# DOCUMENT 00 90 10

## ADDENDUM No. 1

- A. The Construction Contract is known as North Street, Harrisville to Wall.
- B. Date of this Addendum: February 14, 2023.

North Street- Harrisville to Wall

C1.2

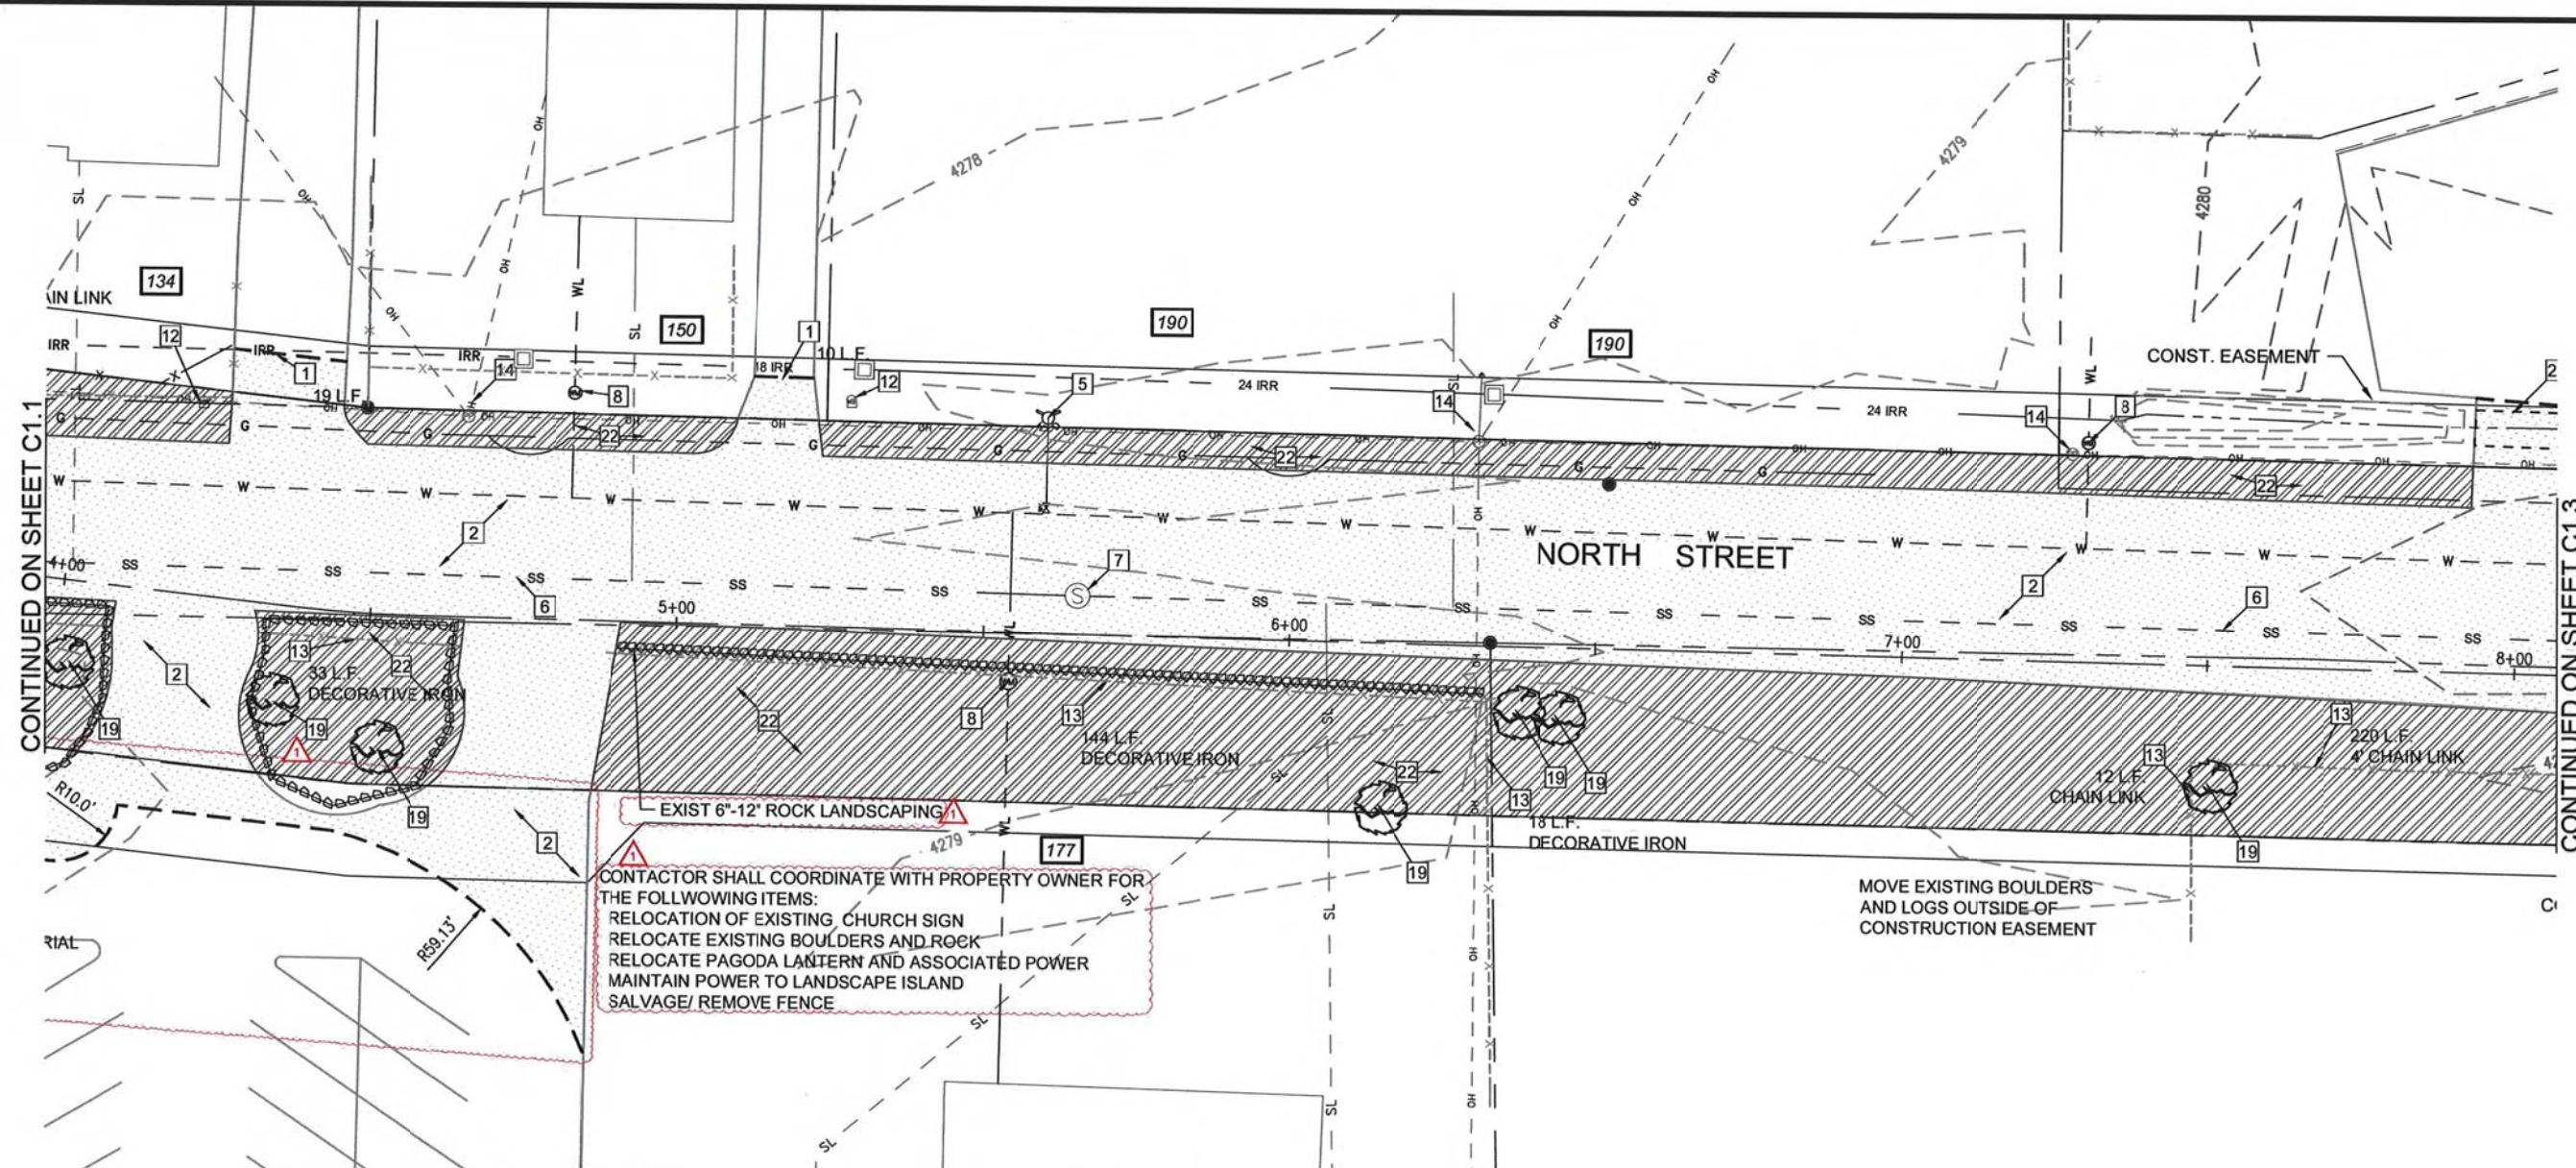
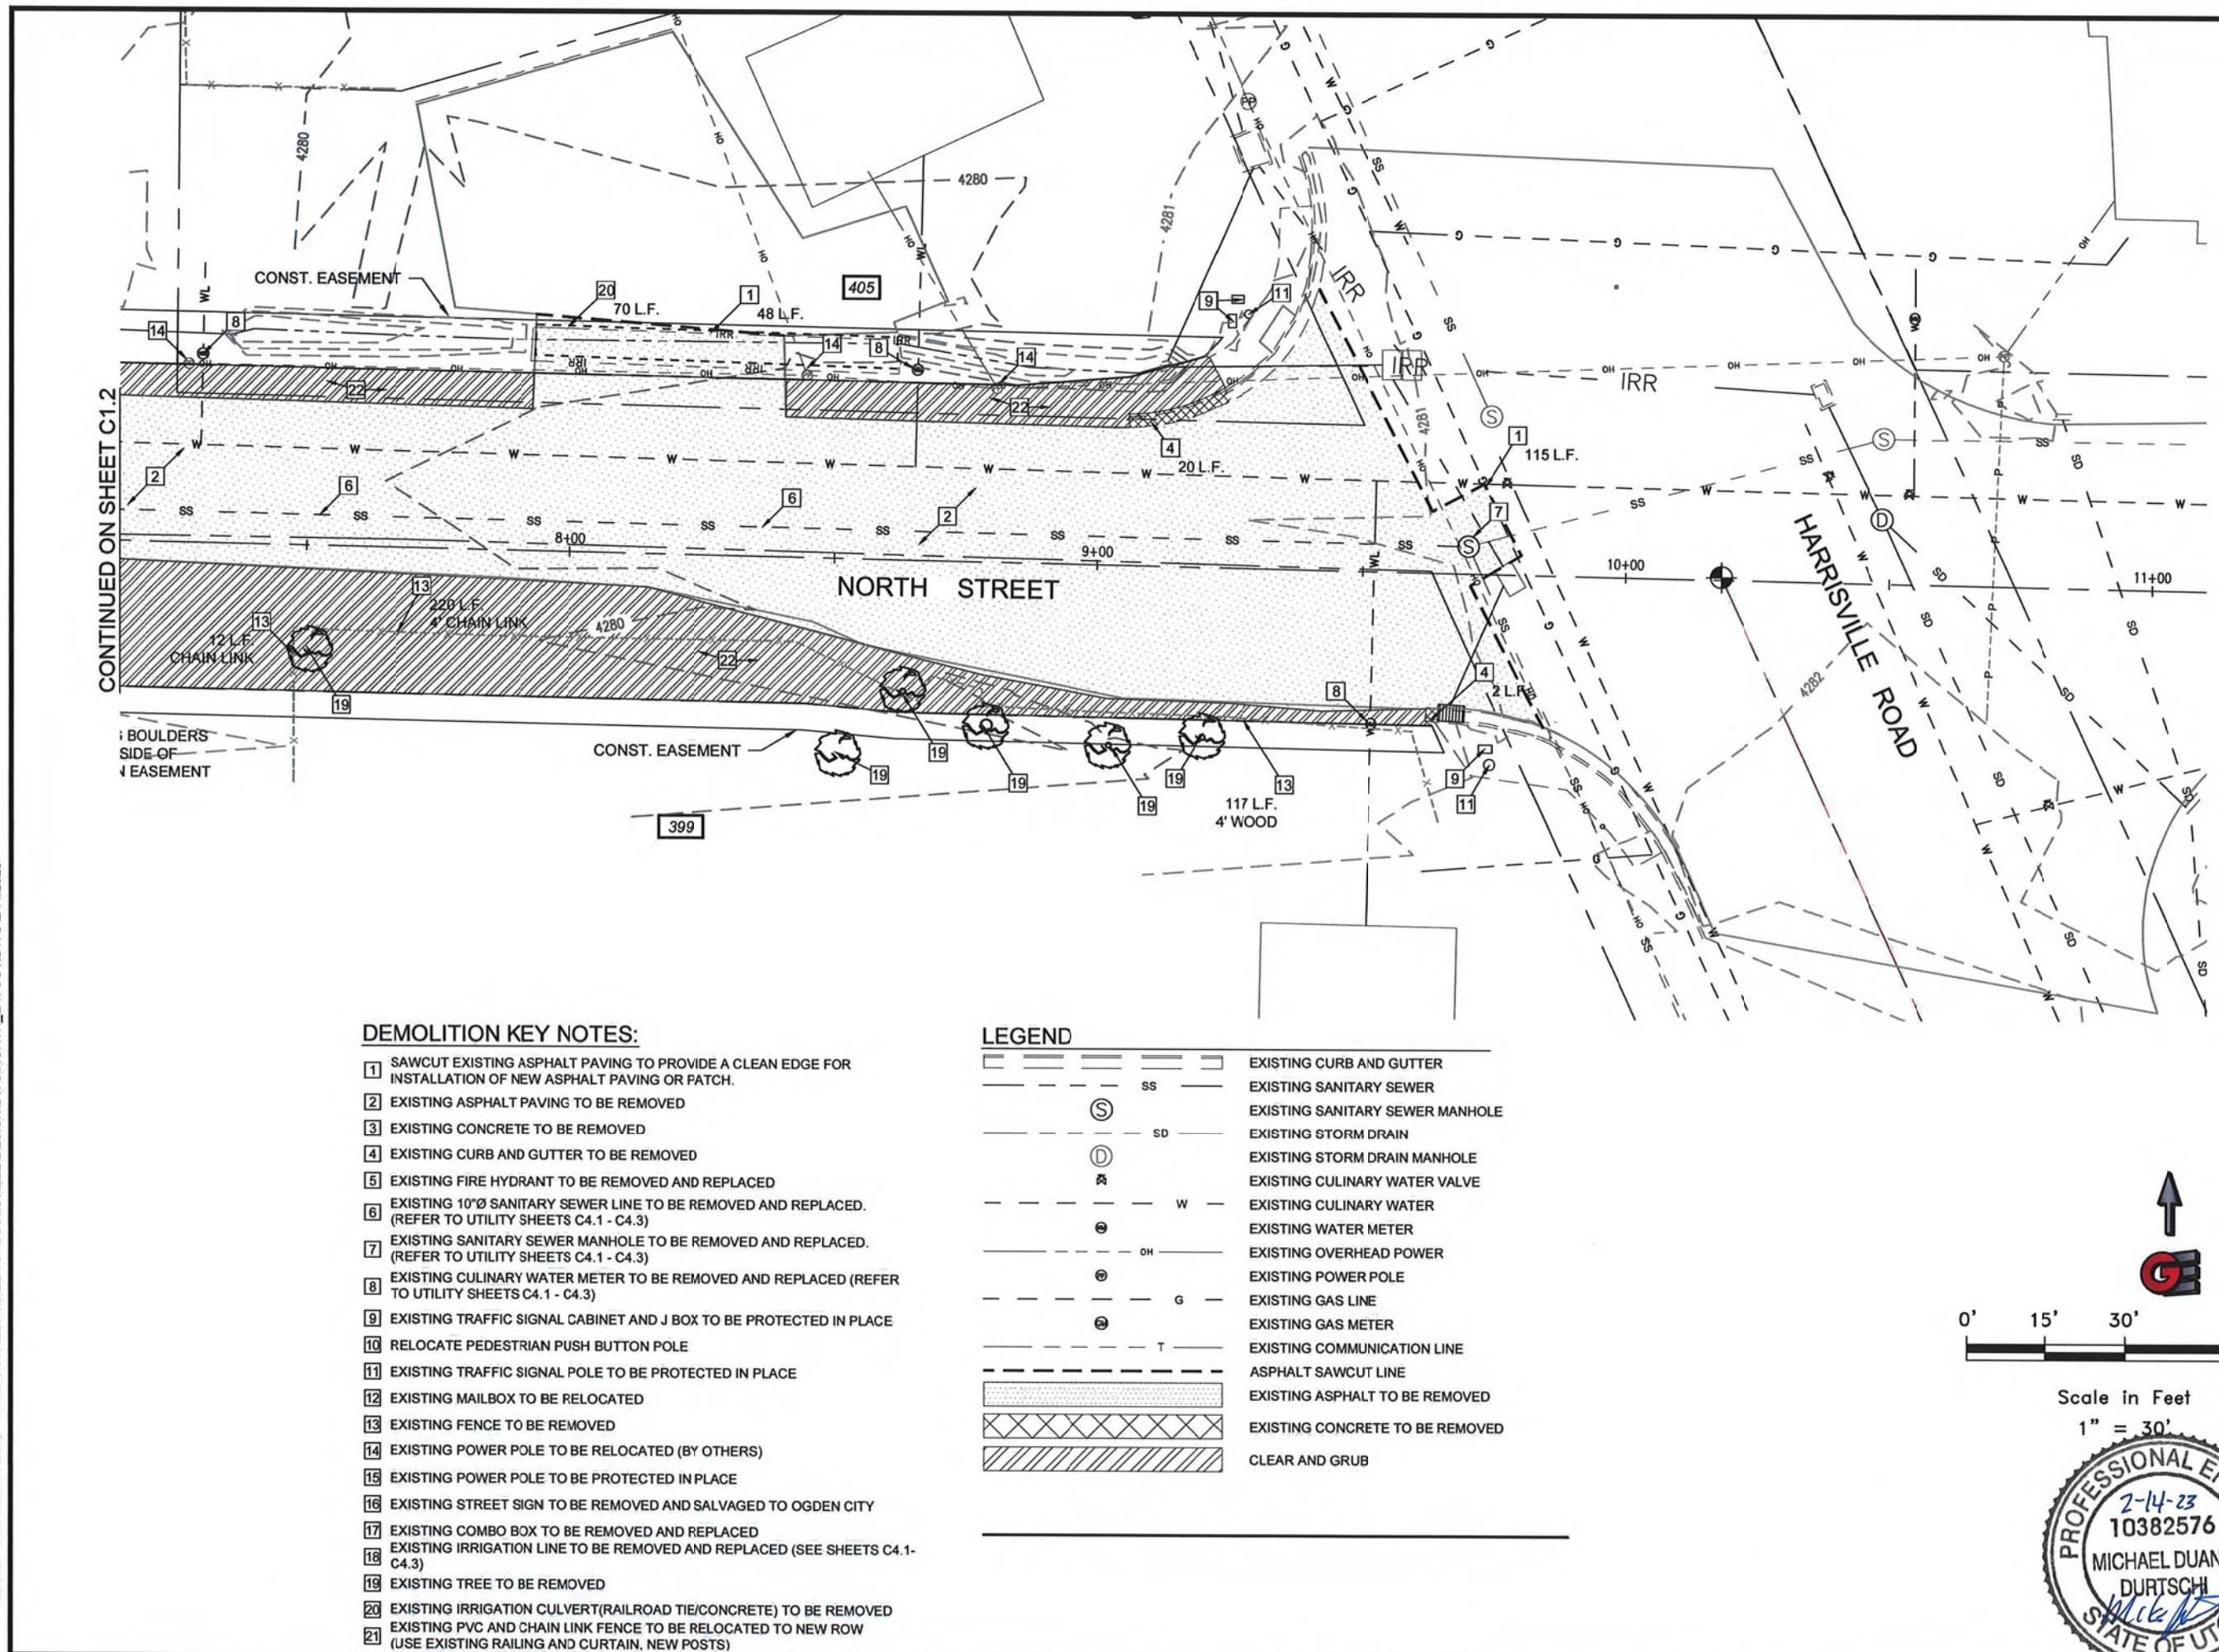
- C. Added following items to Sheet C1.1 and C1.2 – Demolition Plan:
  - i. “CONTACTOR SHALL COORDINATE WITH PROPERTY OWNER FOR THE FOLLOWING ITEMS: RELOCATION OF EXISTING CHURCH SIGN, RELOCATE EXISTING BOULDERS AND ROCK, RELOCATE PAGODA LANTERN AND ASSOCIATED POWER, MAINTAIN POWER TO LANDSCAPE ISLAND, SALVAGE/REMOVE FENCE. “

- ii. ADDED TREE REMOVAL AT STA. 6+17.
  - iii. SAW CUT AND REMOVE ASPHALT ITEMS UPDATED.
- D. Add the following changes to Sheet C2.2 Roadway Sheet:
  - i. Remove/delete callout from “TYPE 2 EMULSIFIED ASPHALT SLURRY SEAL OR UDOT TYPE “C” CHIP SEAL AS SPECIFIED BY CITY ENGINEER”.
